**A Second White Paper Addressing Enhanced Radon  
Releases from the K-65 Silos at the Fernald Site**

Contract No. 200-2009-28555

Prepared by U. Hans Behling, PhD  
S. Cohen & Associates  
1608 Spring Hill Road, Suite 400  
Vienna, VA 22182

April 2010

Exhibit 1: Figure 15 from RAC 1998

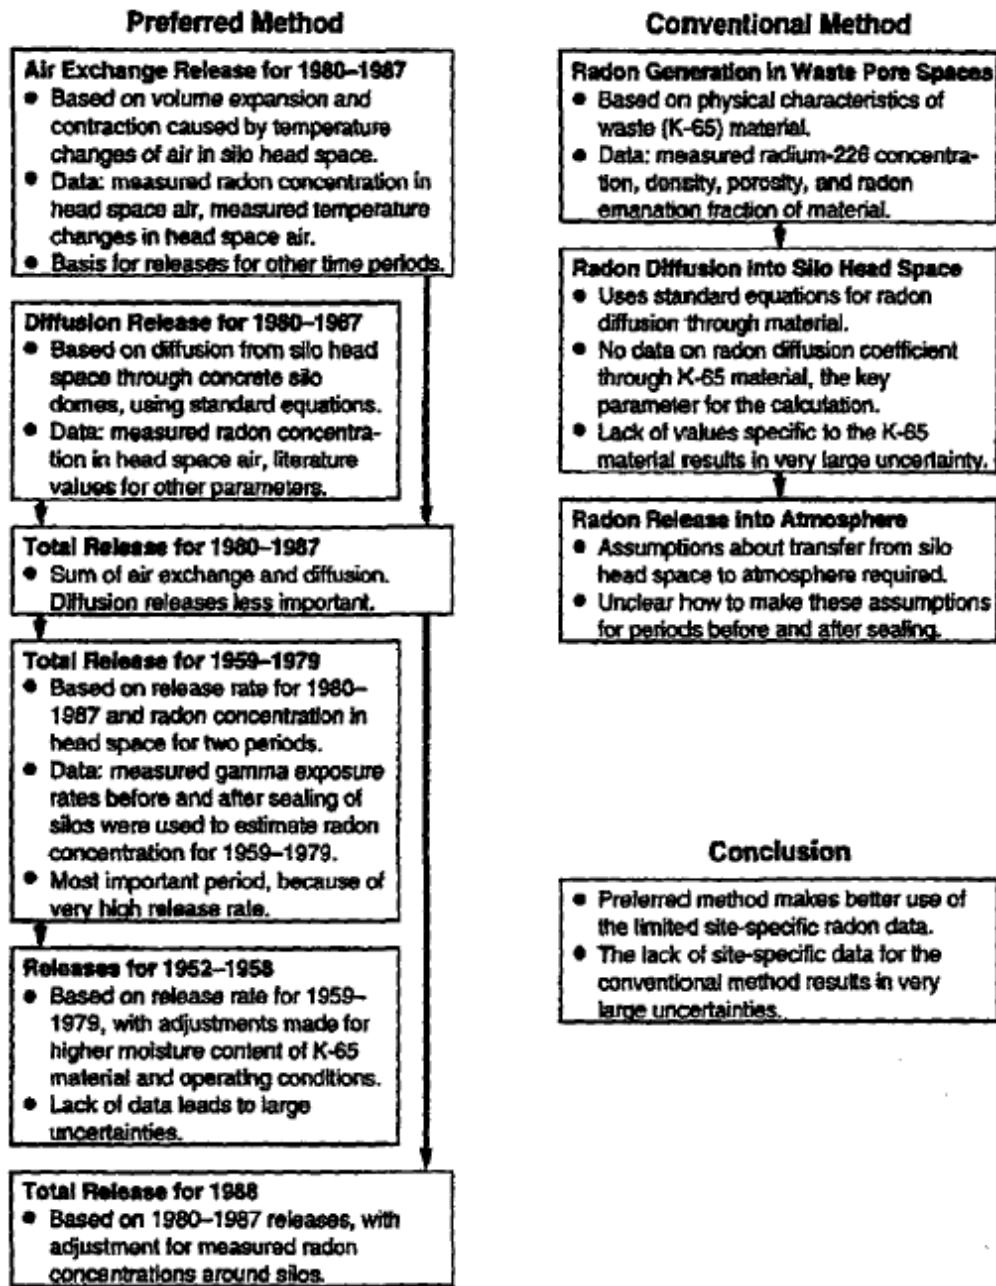
For convenience, “Figure 15” cited above is reproduced herein as Exhibit 1. Of significance are statements that acknowledge the limitations and high uncertainties of these models.

Exhibit 2: Figure 16 from RAC 1998

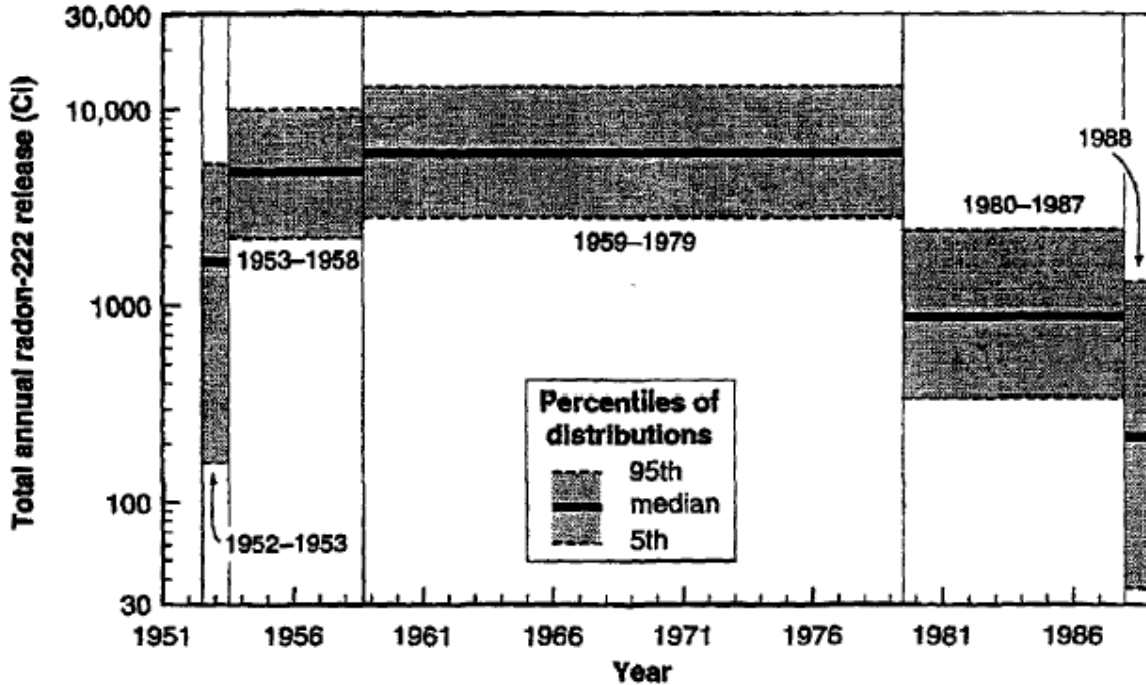
Revised estimates of annual release rates for the **preferred method** are cited by RAC (1998) in Figure 16 and reproduced herein as Exhibit 2. Figure 17 (reproduced herein as Exhibit 3) presents a comparison between release estimates derived in behalf of the RAC (1998) **preferred method** and the RAC (1995) **conventional method**. According to the authors of the two RAC reports, while the addition and/or refinements of model parameters only modestly affected the median values, there was a significant reduction in the uncertainty of release rates.

Exhibit 3: Figure 17 from RAC 1998

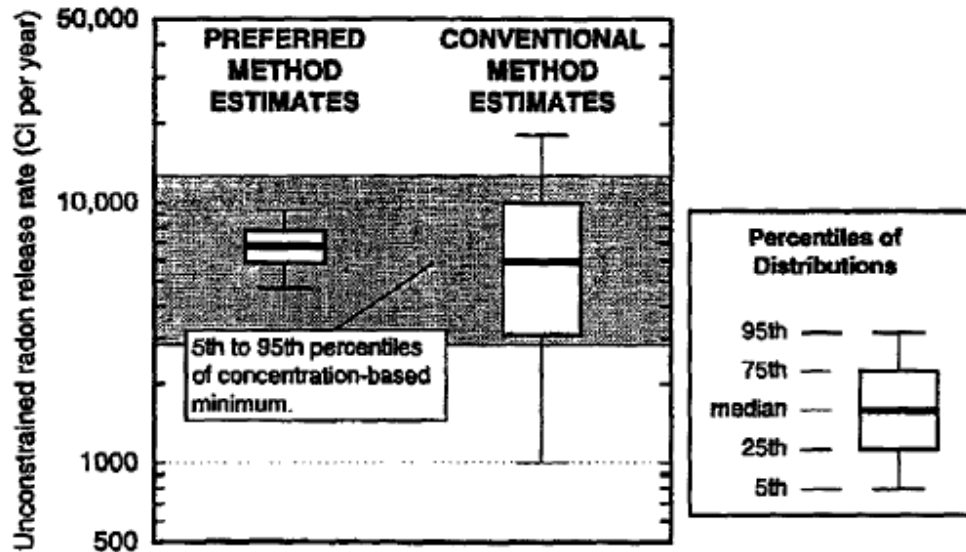
Inspection of Exhibit 3 also shows that, in addition to RAC’s **preferred method** estimates and its **conventional method** estimates, the authors identified yet a third method, referred to as the **concentration-based minimum unconstrained release rate**, shown by the gray band. The issue of “unconstrained” will be discussed in greater detail in Section 3.1 below.
